1001 JOHN ST

SEATTLE WA, 98109
DPD# 3020563

COMFORT LETTER
JUNE 14, 2017

06. OPEN SPACE

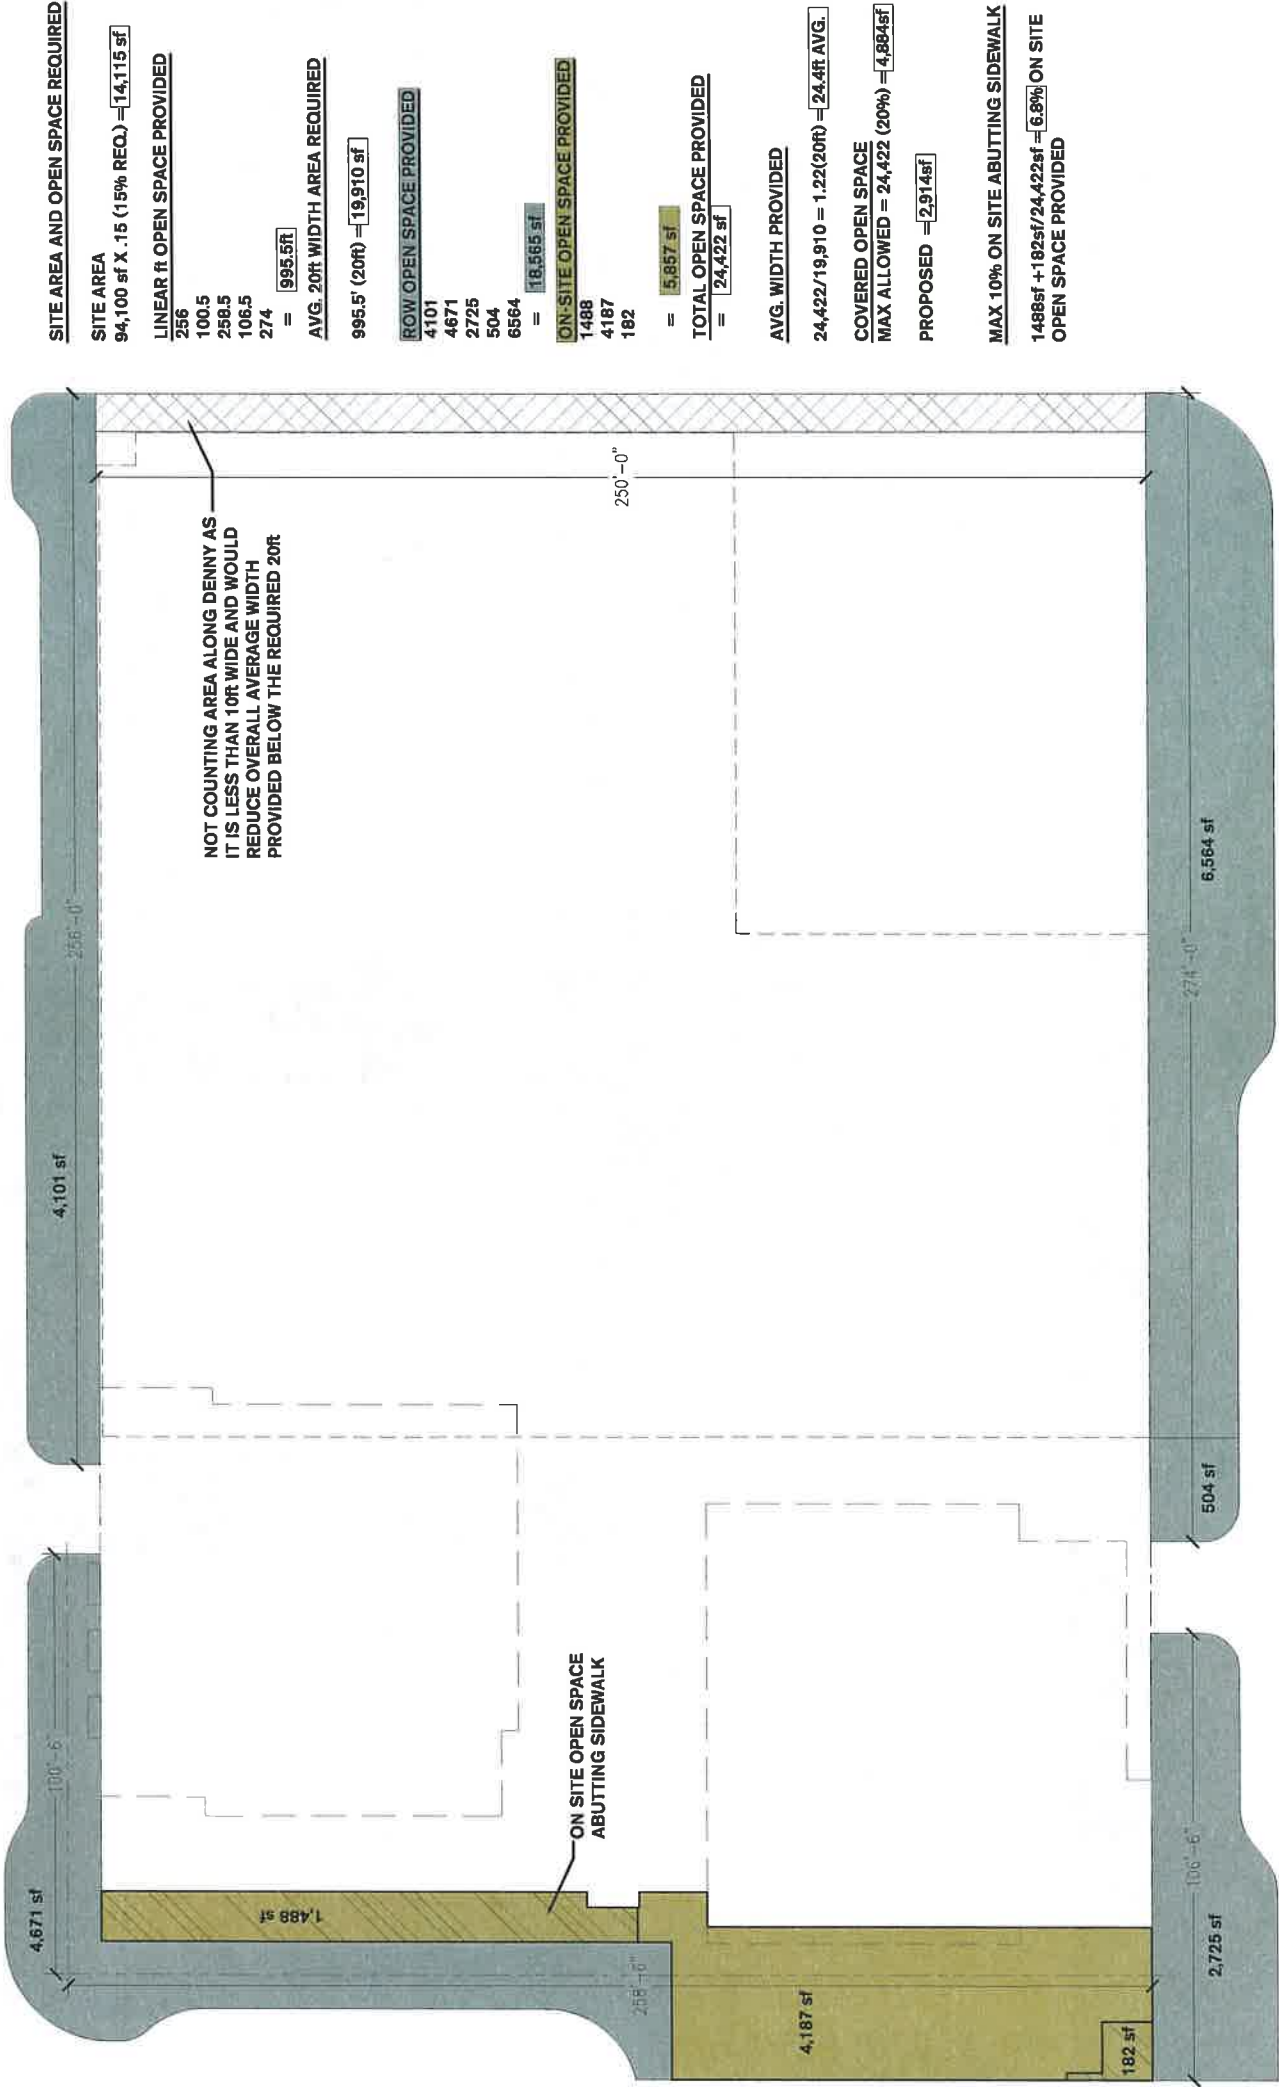
In lieu of providing all required open space on-site we are adopting the previous departure request from 121 Boren, to allow us to count surrounding sidewalk area which meets all the qualifying standards of open space. Is this an acceptable strategy for reaching open space requirements?

23.48.245.2.b.2

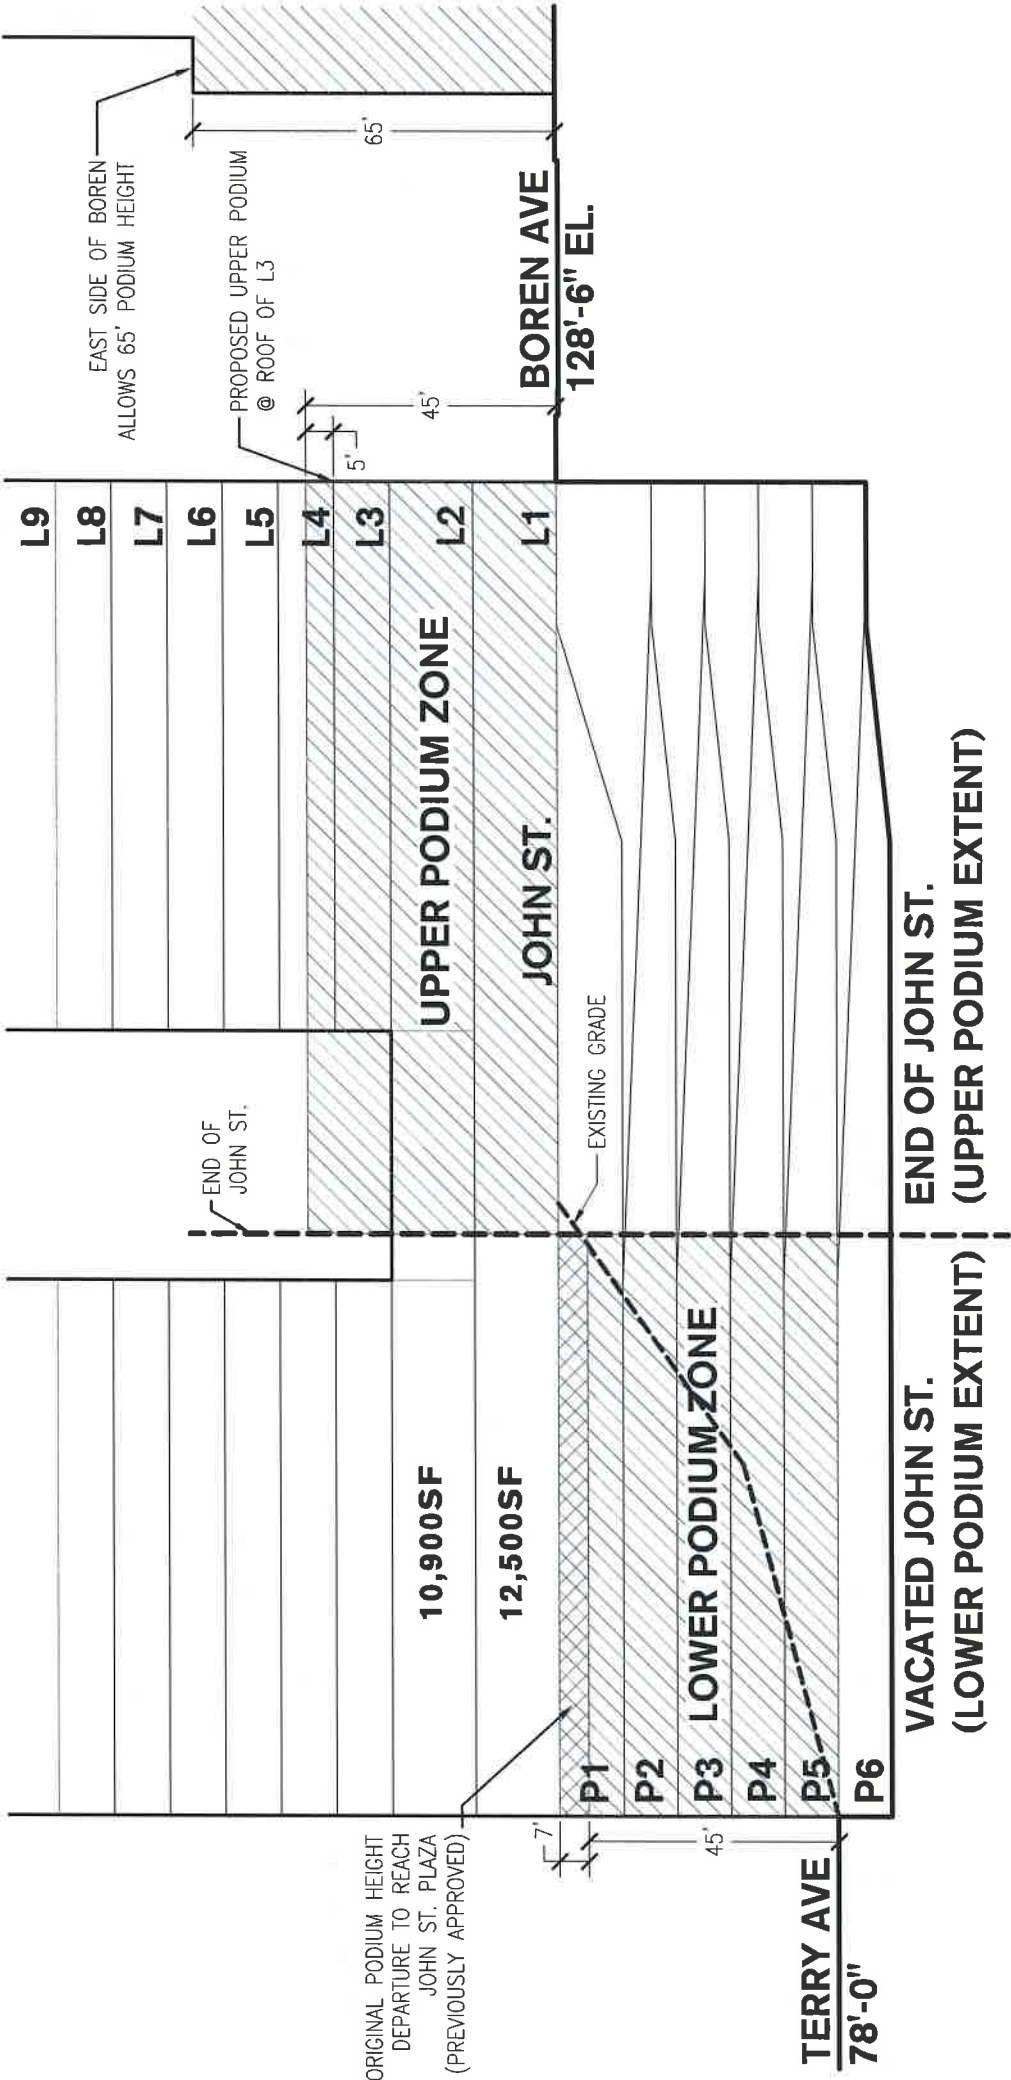
Code section 23.48.245.2.b.2 states any single floor above the podium height is limited to 11,500sf. If it is determined L1 is over this limit, is this departable? The code refers specifically to "residential area" if L1 doesn't include residences and is an amenity level with some commercial area does L1 still count as "residential area" required to meet the floor area limits?

L1 shown in the adjacent diagram is the only level both above our podium level and over the floor area limit of 11,500sf. Because this level is not utilized as a residential floor containing any residential units does it still fall under the definition of "residential area" as governed by floor area limits?

Does commercial area in the form of designated retail space contribute to the "residential area" of L1? If it doesn't can the amount of retail area be subtracted from L1 to lower the total area to below the 11,500sf area limit?

For example: If we have retail area equal to 1,000sf or more can that area be subtracted from L1 (12,500sf) so the remaining countable "residential area" is less than 11,500sf?

23.48.245.2.b.1

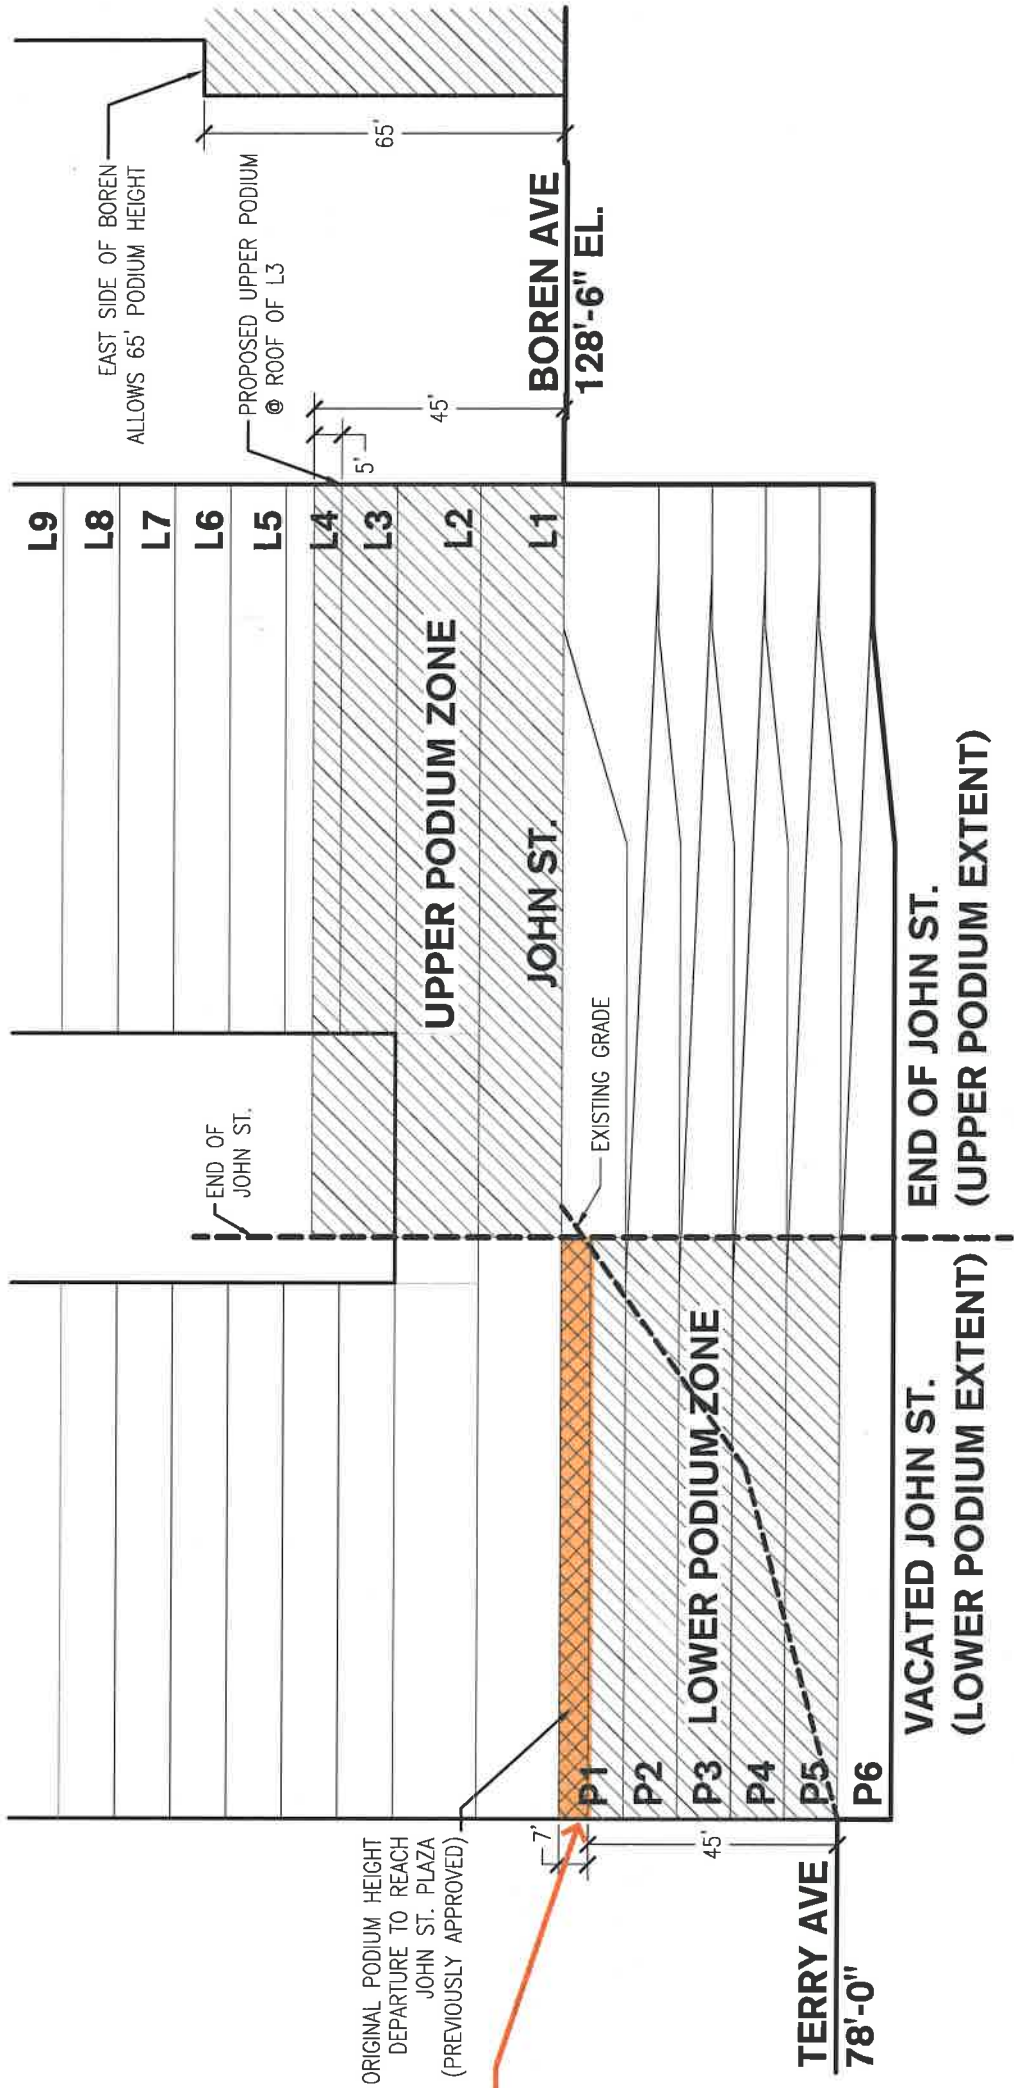
We are proposing to start calculating average floor plate above podium height, including above the podium departure needed from Terry Ave. to reach the John St. elevation. Is this strategy acceptable?

In order to meet the average gross floor area limits for residential use above the podium we are proposing not counting garage area within the departure dimension needed to reach the John St. elevation (shown in adjacent diagram)
